FDA Executive Summary

Prepared for the October 1, 2014 meeting
of the Gastroenterology and
Urology Devices Panel

P130002
SonaCare Medical, LLC

Sonablate® 450

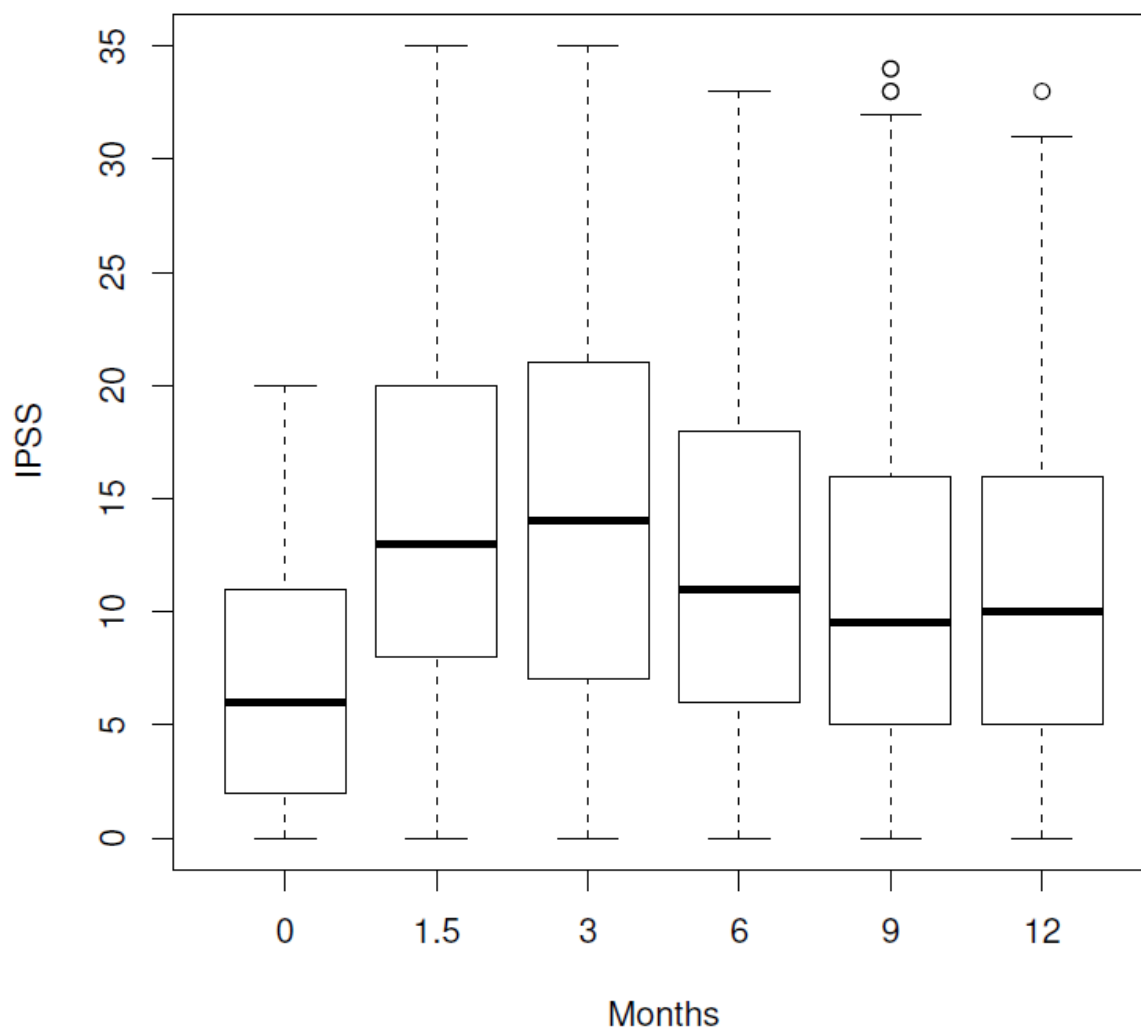
The rate of erectile dysfunction after treatment with the Sonablate was 88% according to IIEF-5 scores. Previous studies of alternate salvage treatments including radical prostatectomy, robot assisted radical prostatectomy, cryotherapy, and brachytherapy have erectile dysfunction rates that range from 61-100%.⁶ The rate of erectile dysfunction after

treatment with the Sonablate seems to be in the range of those seen after other salvage therapies.

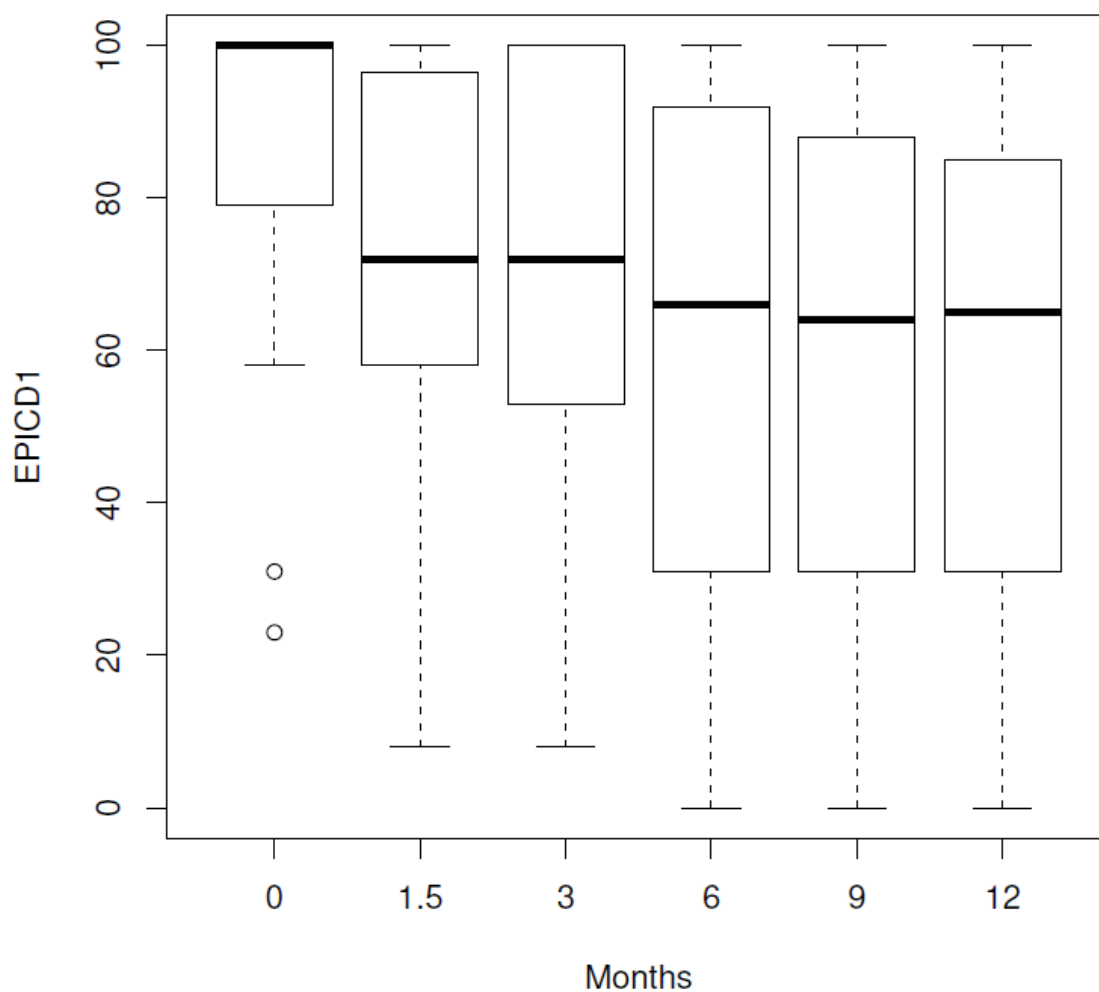
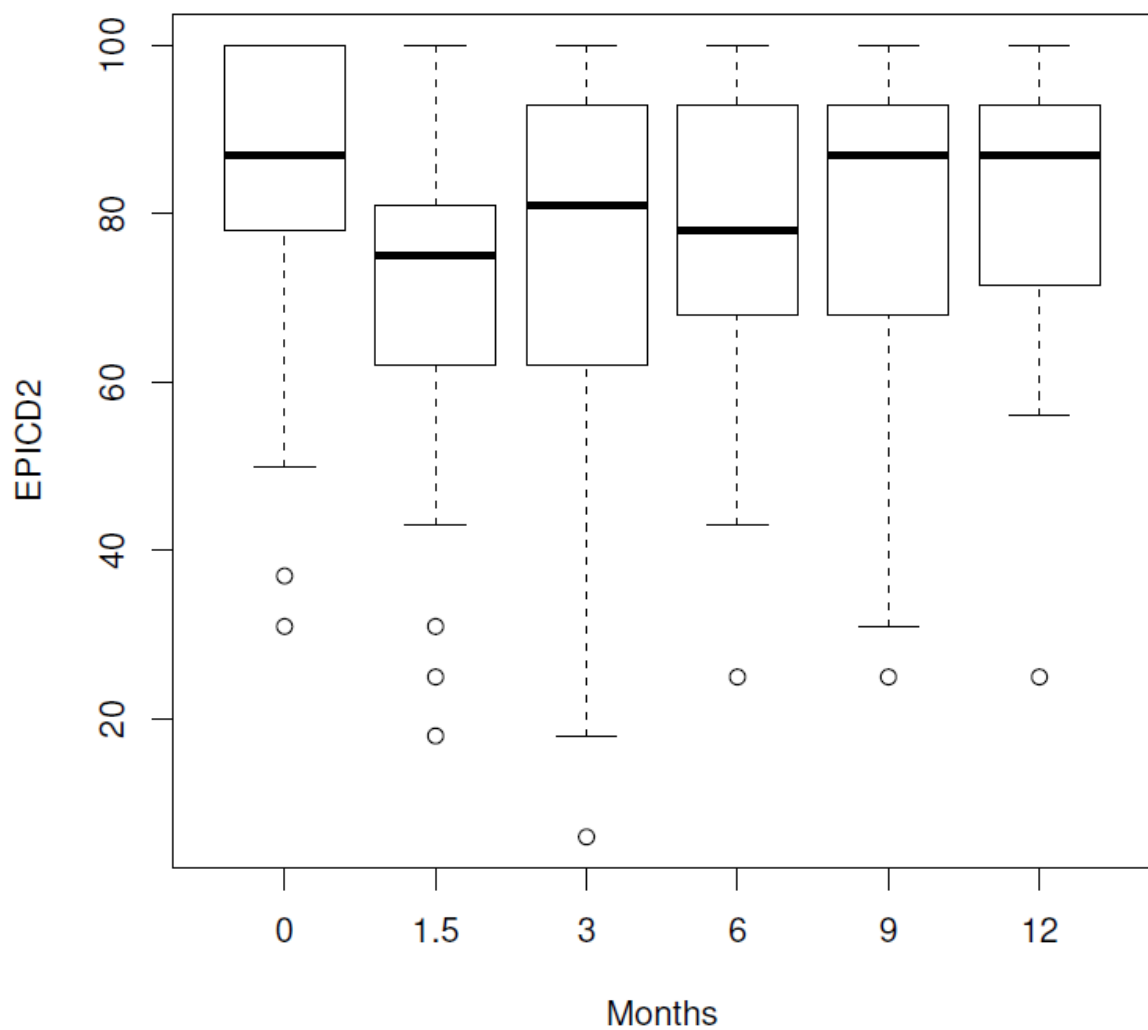
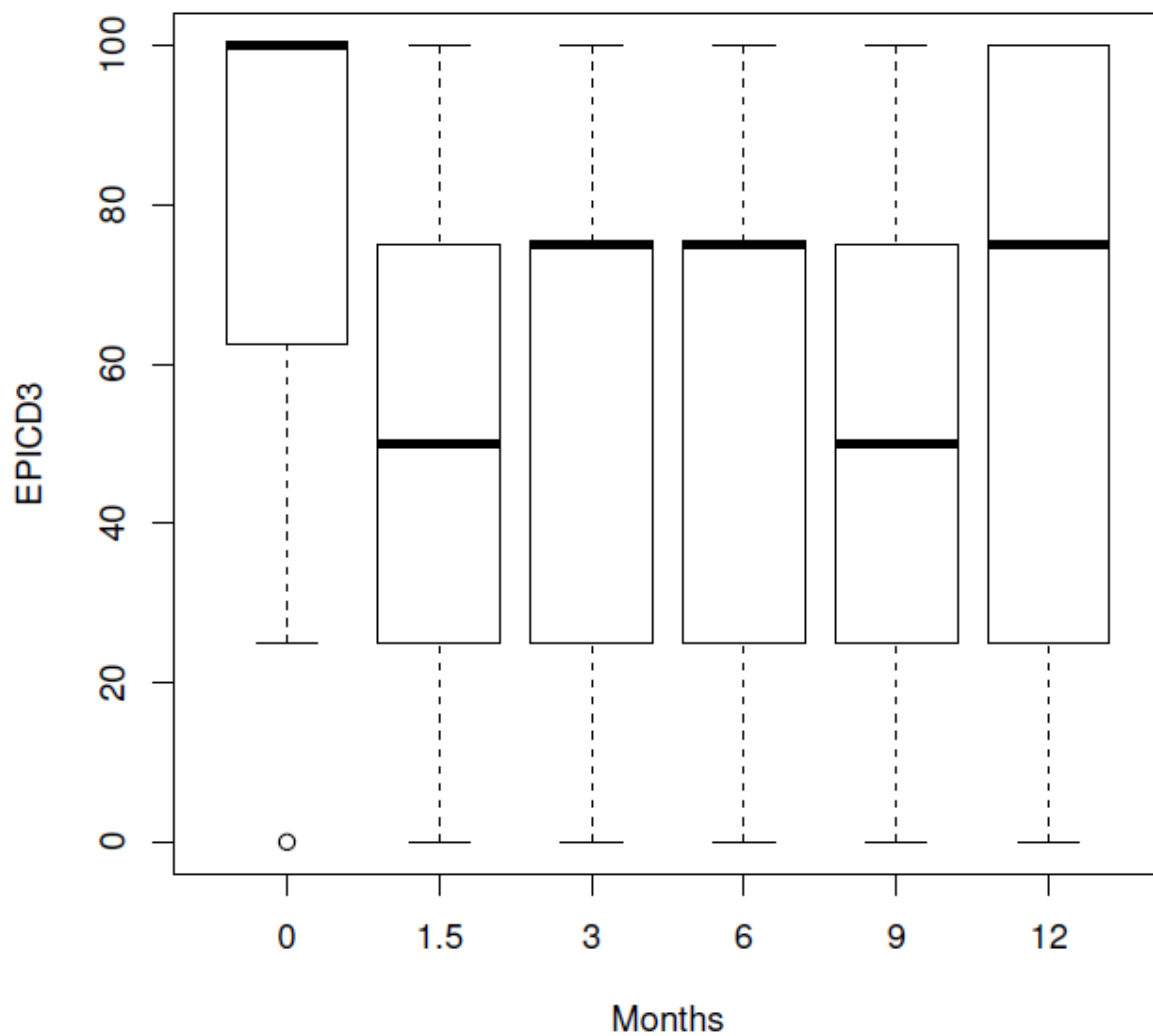
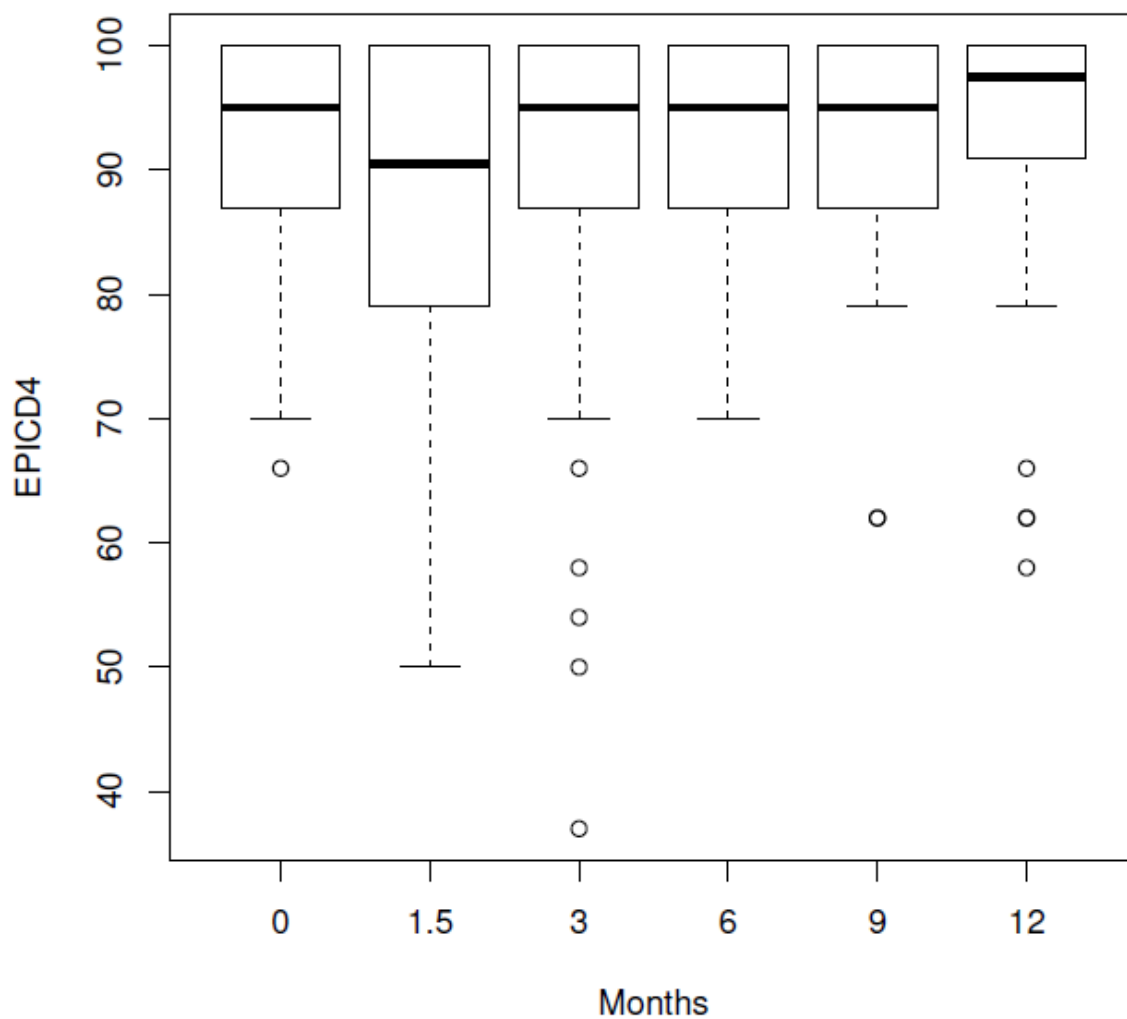
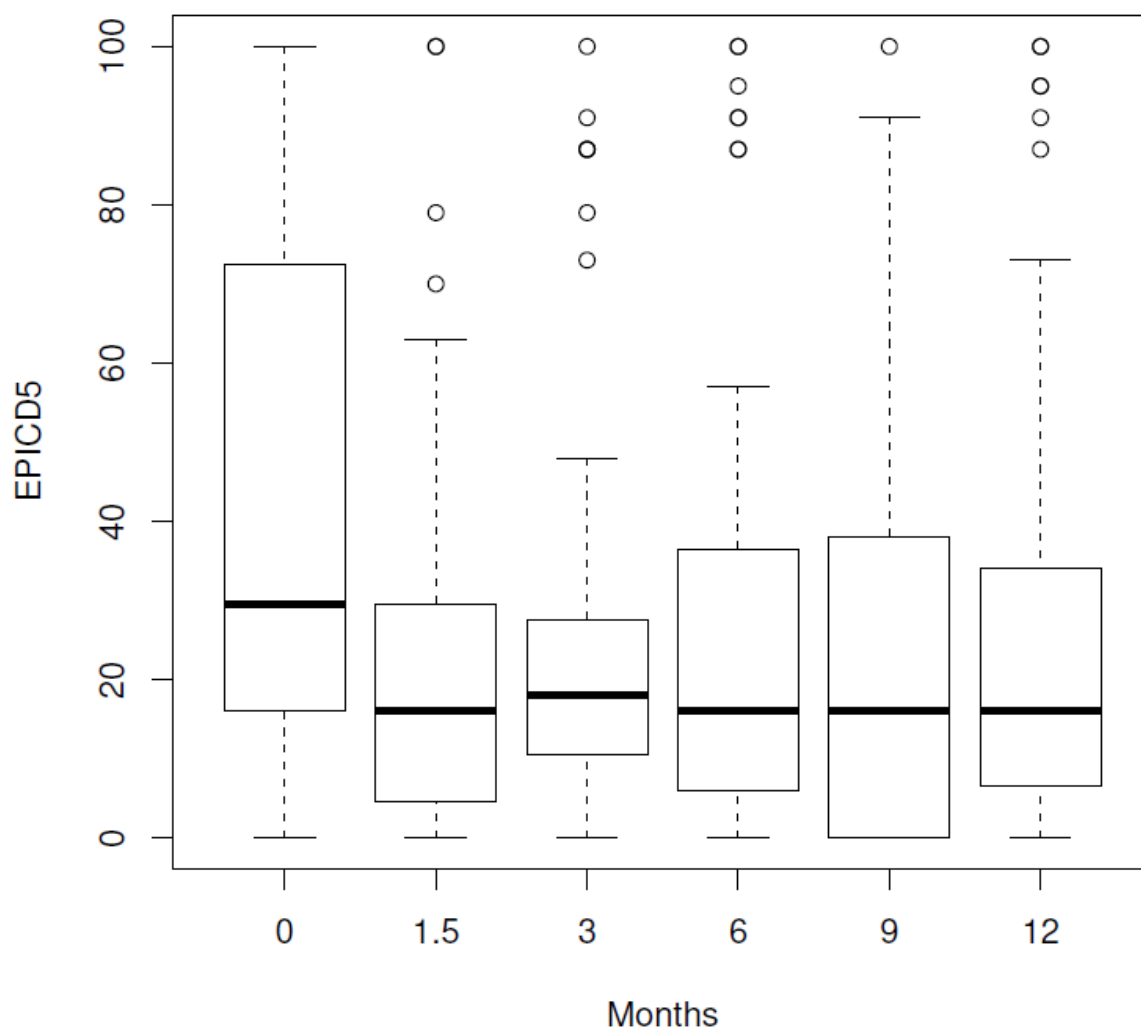
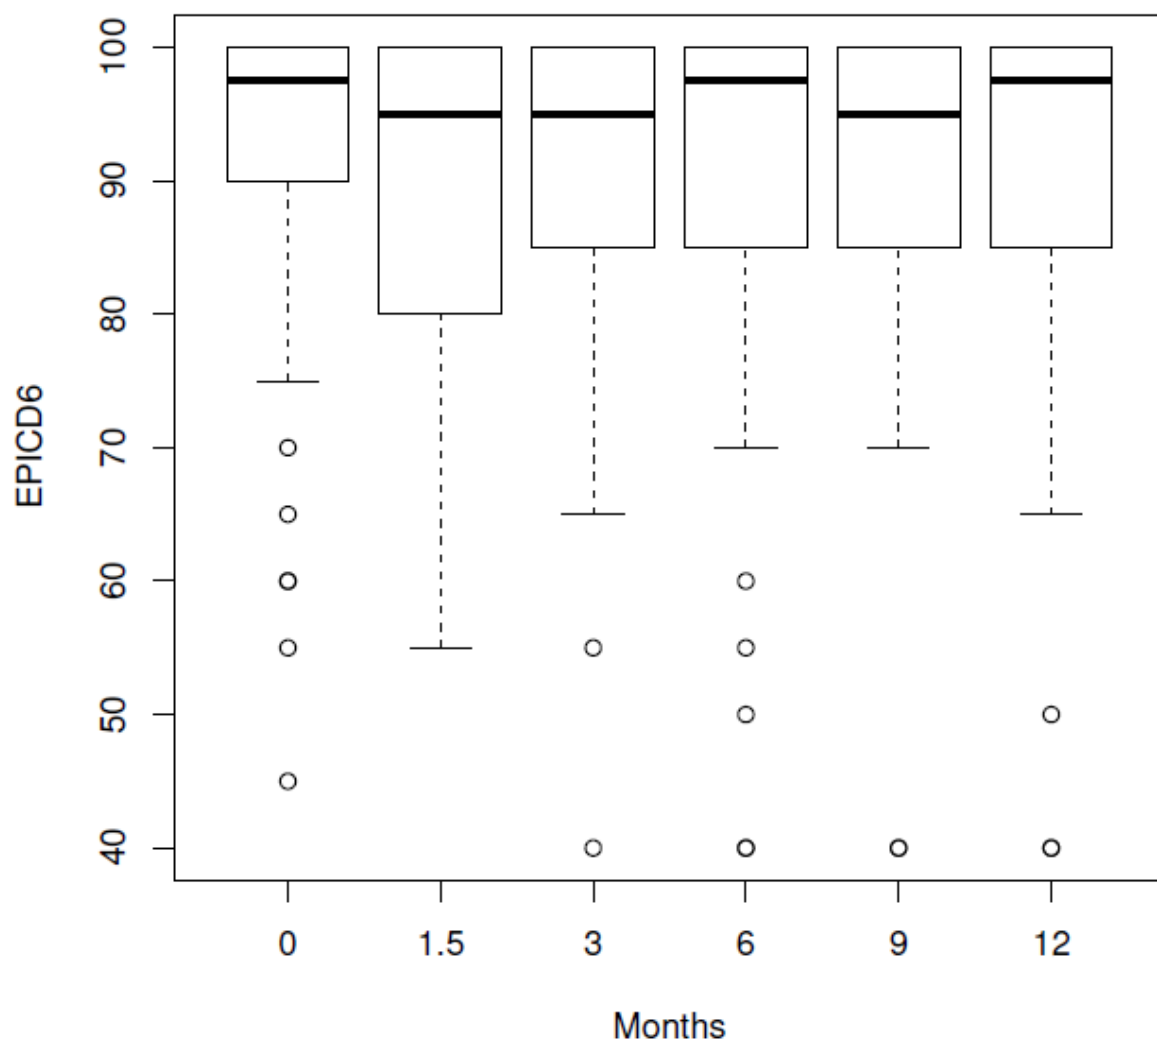
FDA Comment: Since the EPIC-26 evaluation was added after 49 subjects had started the study, the results should be used with caution.
